## REMARKS

The drawings have been amended to indicate that Figures 1 and 2 are Prior Art, as requested by the Examiner and indicated in the Specification. Figure numbers have been added to figures 1, 2, 3 and 4. No new matter has been added.

FIG. 1

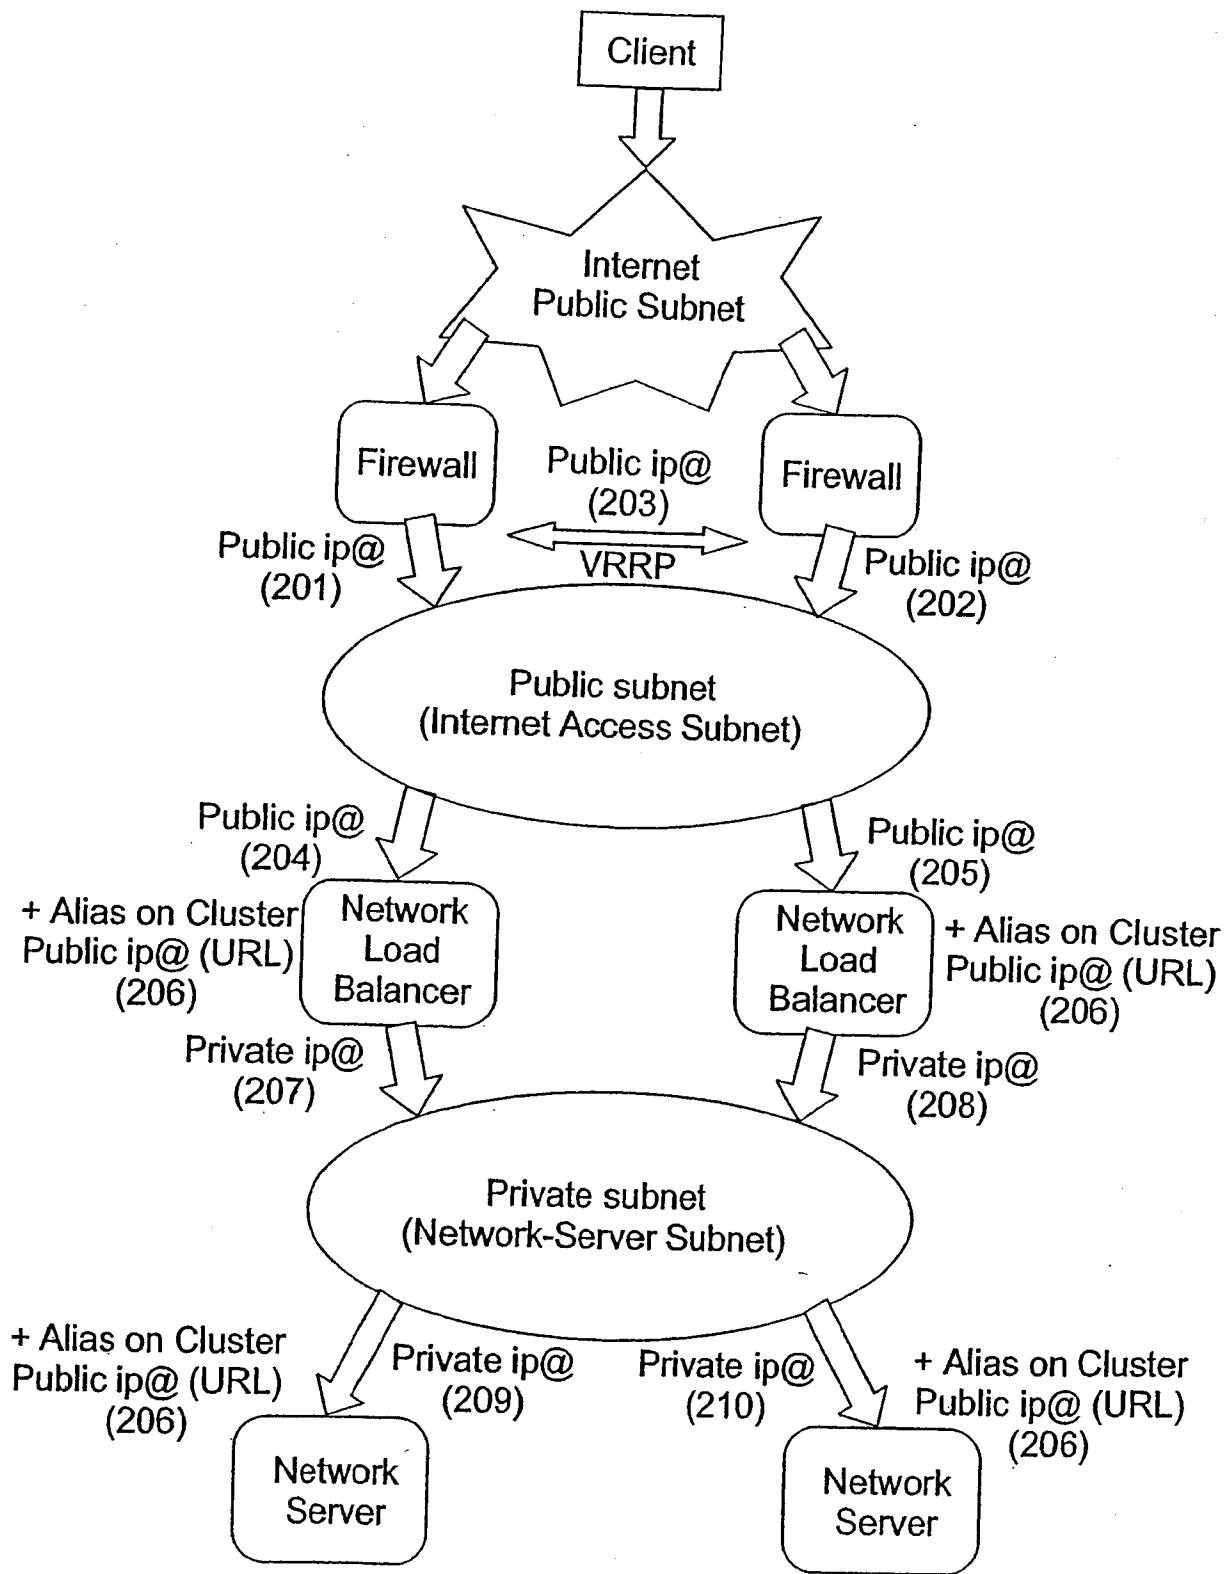
(PRIOR ART)
